Urgent Device Correction

Elevated Temperature of Receive Coil Components When Using Select Ciné Treatment Imaging Sequences

UDC 2020-001

Figure 3: Distance between receive coil and inner surface of bore wall is more than 5 cm

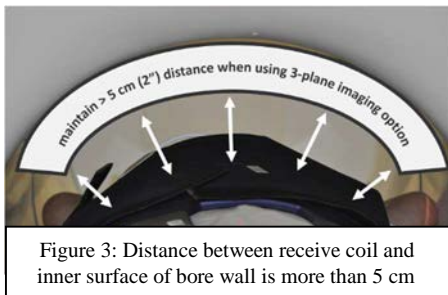
The extreme testing conditions showed that the use of 3 Plane or 8 fps cine' treatment imaging sequences while the receive coil is positioned close to the bore wall causes some of the gray plastic electronic boxes ("feedboard boxes" Figure 1 & 2) attached to the receive coil, to reach an elevated temperature. If the feedboard boxes are in contact with the patient or user, there is the potential risk of injury.

During radiation delivery, the MRIdian system continually acquires images. During this continuous imaging, the receive coils are exposed to RF energy. The amount of RF energy exposure is directly related to the cine' treatment imaging sequences being used. The higher RF energy associated with the 3 Plane and 8 fps sequences and the proximity of the coil to the bore wall contribute to the elevated temperature of the feedboard boxes.

Do: Maintain a distance of at least 5 cm (~2") between the receive coil and the inner surface of the bore wall when using 3 Plane ciné treatment imaging (Figure 3 & 4).

Do Not: Select 3 Plane ciné treatment imaging if a distance of at least 5 cm (~2") cannot be maintained between the receive coil and the inner surface of the bore wall during treatment.

Figure 4: 3 Plane imaging option screen

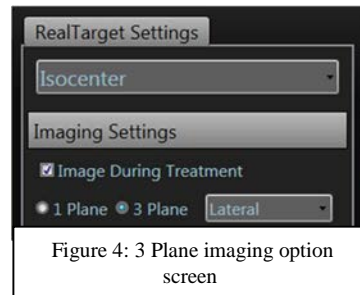
1. Using the optional, user-selectable, 3 Plane cine' treatment imaging sequence. This feature is only available in Treatment Planning and Delivery System (TPDS) software version 5.2.5 or earlier.
2. Using the optional, user-selectable, 8 fps cine' treatment imaging sequence. This feature is only available in TPDS software version 5.3 or later with 8 fps enabled.

Do Not: Use 8 fps ciné treatment imaging until further guidance is provided by ViewRay.

Do: Use 4 fps ciné treatment imaging when treating a patient.
